Project	<b>IEEE 802.16 Broadband Wireless Access Working Group</b> < <a href="http://ieee802.org/16">http://ieee802.org/16</a> >	
Title	Some Clarifications on Virtual RS-Group Concept	
Date Submitted	2007-04-25	
Source(s)	Israfil Bahceci, Hang Zhang, Peiying Zhu, Mo-Han Fong, Wen Tong, David Steer, Gamini Senarath, Derek Yu, Mark Naden, G.Q. Wang	Voice: +1 613 7631315 <a href="mailto:wentong@nortel.com">[mailto:wentong@nortel.com]</a>  <a href="mailto:pyzhu@nortel.com">[mailto:pyzhu@nortel.com]</a>
	Nortel 3500 Carling Avenue Ottawa, Ontario K2H 8E9	
Re:	A response to a Call for Technical Proposal, <a href="http://www.ieee802.org/16/relay/docs/80216j-07_013.pdf">http://www.ieee802.org/16/relay/docs/80216j-07_013.pdf</a>	
Abstract	We provide editorial changes on 6.3.9.16.3.1 and clarifications on RS grouping concept regarding the network entry, topology configuration and data forwarding.	
Purpose	To incorporate the proposed text into the P802.16j Baseline Document (IEEE 802.16j-06/026r3)

## Some Clarifications on Virtual RS Group Concept

Figure 1 Examples for RS group topology

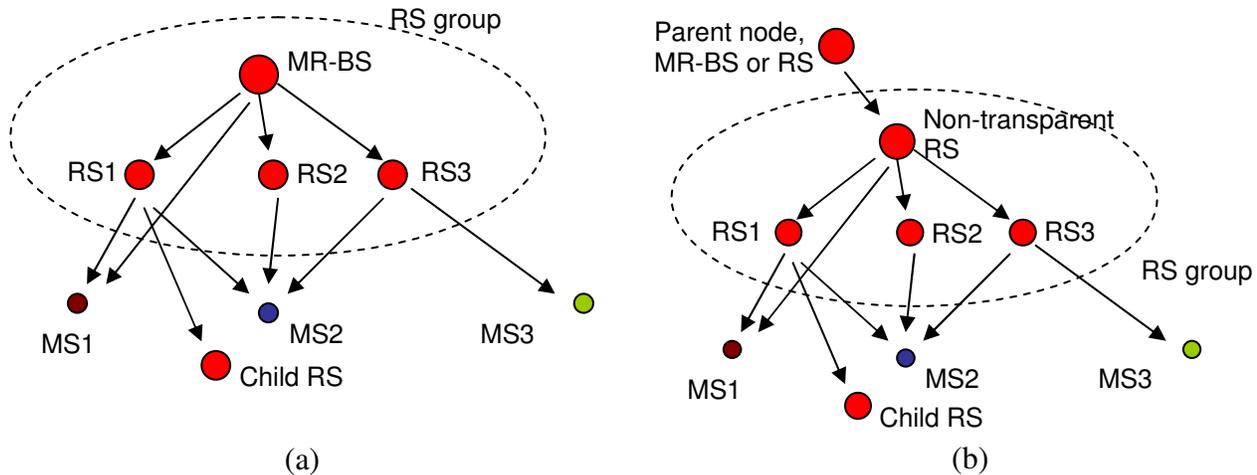
If an RS group includes an MR-BS, than the RS members of the group may be imagined as the second hop non-transparent RSs. If the group leader is a non-transparent RS, then this group leader may be imagined as a non-transparent RS at the  $j^{\text{th}}$  hop, and all other members as a transparent RS either at  $j^{\text{th}}$  hop, or at the  $(j+1)^{\text{th}}$  hop. Two examples are provided in Figure 1.

An RS-group shall also be enabled for selective forwarding. For example, in Figure 1.a., assume RS1 serves to MS1 and RS3 serves to MS3 (e.g., because the associated wireless links are very good). In that case, RS1 may only need to forward the data for MS1, and RS3 to MS3, although both RS1 and RS3 have the traffic data for both mobiles. This can reduce the unnecessary interference and resource usage at both RSs. Note that there may another MS, e.g., MS2, which can receive signals from all RS1, RS2, and RS3 and perform RF diversity combining. An RS group already enables that sort of transmission.
